香港城市規劃委員會依據城市規劃條例擬備的啟德(九龍規劃區第22區)分區計劃大綱圖
TOWN PLANNING ORDINANCE, HONG KONG TOWN PLANNING BOARD
KOWLOON PLANNING AREA No. 22 - KAI TAK - OUTLINE ZONING PLAN

**SCHEDULE OF AMENDMENTS TO THE
APPROVED KAI TAK OUTLINE ZONING PLAN NO. S/K22/4
MADE BY THE TOWN PLANNING BOARD
UNDER THE TOWN PLANNING ORDINANCE (Chapter 131)**

**Item 3 Amendments Incorporated in the Draft Kai Tak Outline
Zoning Plan No. S/K22/5 (Paper No. TFKT/07/2017)**

**Amendments Incorporated in the Draft Kai Tak
Outline Zoning Plan No. S/K22/5**

圖一

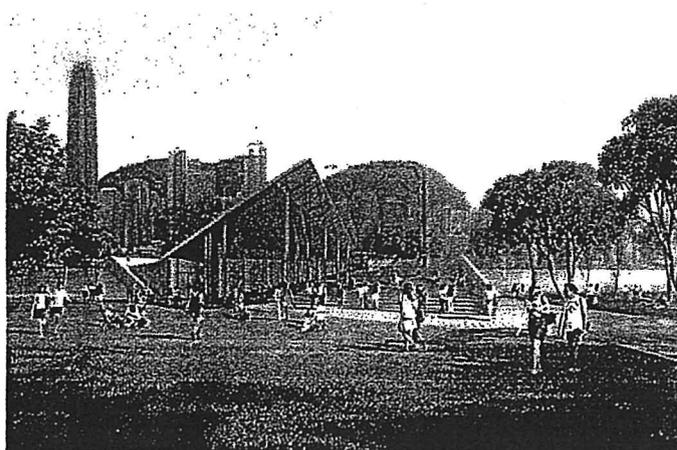
1. 規劃署/VTC 於 2017 年 1 月 20 日向城規會建議將茶果嶺偉業街及偉樂街兩旁的一幅在 S/K22/4 計劃中原本規劃為休憩及其他用途並原定為「茶果嶺公園」(見圖一)的海旁用地更改至 GIC 用途,並在該地上興建龐大的 VTC 校舍。城規會續於 2017 年 2 月 17 日就 S/K22/5 草圖刊憲,提出將該片用地更改至 GIC 用途(項目 W1 及 W2)。對政府此計劃及城規會提出的改劃,我們感到極度忿怒及提出強烈反對。
2. 此外,政府在計劃過程中,沒有就更改海旁用地用途進行全面公眾諮詢,更沒有對受最大影響的三萬麗港城居民及鄰近地區居民進行足夠的諮詢,完全漠視民意。在 11 月 1 日的區議會會議中多位議員已表明對建議有保留,要求政府重新檢討茶果嶺海濱規劃再諮詢區議會;而在 11 月 18 日海濱事務委員會啟德工作小組會議中,委員亦認為政府建議修改的啟德發展計劃顯著有違了海濱發展的原意,表明不接納並要求重新檢討(政府在其後的海濱事務委員會大會未有跟進茶果嶺海濱規劃),但政府竟然豪不尊重任何諮詢機制,獨斷獨行,甚至事後向居民詐稱區議會對計劃無反對意見而令居民一道對區議會失去信心。我們相信區議會當時也未知擬建的 VTC 校舍的規模龐大(三棟 60-70 米高大樓,其高度可達麗港城樓宇的 21 層),地面面積媲美整個添馬政府總部,樓面面積約為政府總部兩倍或約等於 15 幢麗港城樓宇,而校舍包括四層有 60 間酒店房間,誤以為只是一般 IVE 校舍(如同中學)的規模,結果讓規劃署蒙混過關。對於現政府的獨行獨斷、漠視民意、蔑視所有諮詢架構同機制的施政態度,及鬼祟不誠實的手法,我們亦表示極度忿怒,及對此政府的誠信和管治信心盡失。政府這樣的行徑,只會不斷加深社會矛盾和市民的反政府情緒。
3. 我們強烈要求政府公平對待觀塘區居民,立即落實原有上述用地作休憩用途的計劃,將上述用地發展為茶果嶺海濱公園(例如包括單車徑、緩跑徑)(如同西九公園概念,見圖二),供觀塘、茶果嶺、油塘、藍田等、以至全港市民享用。
4. 我們提出的進一步理據和訴求如下。

圖一

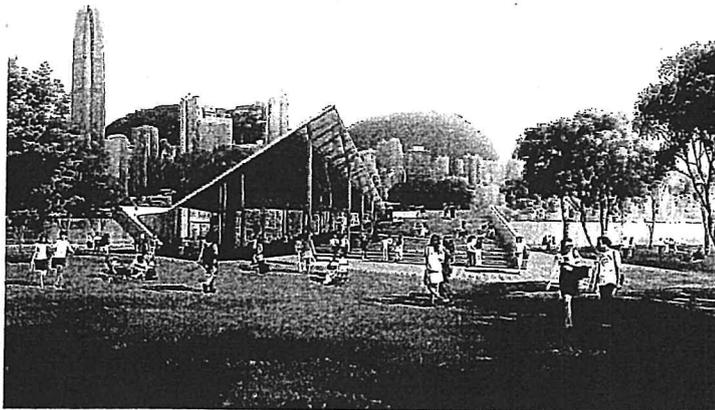
1. 規劃署/VTC 於 2017 年 1 月 20 日向城規會建議將茶果嶺偉業街及偉樂街兩旁的一幅在 S/K22/4 計劃中原本規劃為休憩及其他用途並原定為「茶果嶺公園」(見圖一)的海旁用地更改至 GIC 用途,並在該地上興建龐大的 VTC 校舍。城規會續於 2017 年 2 月 17 日就 S/K22/5 草圖刊憲,提出將該片用地更改至 GIC 用途(項目 W1 及 W2)。對政府此計劃及城規會提出的改劃,我們感到極度憤怒及提出強烈反對。
2. 此外,政府在計劃過程中,沒有就更改海旁用地用途進行全面公眾諮詢,更沒有對受最大影響的三萬麗港城居民及鄰近地區居民進行足夠的諮詢,完全漠視民意。在 11 月 1 日的區議會會議中多位議員已表明對建議有保留,要求政府重新檢討茶果嶺海濱規劃再諮詢區議會;而在 11 月 18 日海濱事務委員會啟德工作小組會議中,委員亦認為政府建議修改的啟德發展計劃顯著有違了海濱發展的原意,表明不接納並要求重新檢討(政府在其後的海濱事務委員會大會未有跟進茶果嶺海濱規劃),但政府竟然毫不尊重任何諮詢機制,獨斷獨行,甚至事後向居民詐稱區議會對計劃無反對意見,令居民一度對區議會失去信心。我們相信區議會當時也未知擬建的 VTC 校舍的規模龐大(三棟 60-70 米高大樓,其高度可達麗港城樓宇的 21 層),地面面積媲美整個添馬政府總部,樓面面積約為政府總部兩倍或約等於 15 幢麗港城樓宇,而校舍包括四層有 60 間酒店房間,誤以為只是一般 IVE 校舍(如同中學)的規模,結果讓規劃署蒙混過關。對於現政府的獨行獨斷、漠視民意、蔑視所有諮詢架構同機制的施政態度,及鬼祟不誠實的手法,我們亦表示極度憤怒,及對此政府的誠信和管治信心盡失。政府這樣的行徑,只會不斷加深社會矛盾和市民的反政府情緒。
3. 我們強烈要求政府公平對待觀塘區居民,立即落實原有上述用地作休憩用途的計劃,將上述用地發展為茶果嶺海濱公園(例如包括單車徑、緩跑徑)(如同西九公園概念,見圖二),供觀塘、茶果嶺、油塘、藍田等、以至全港市民享用。
4. 我們提出的進一步理據和訴求如下。
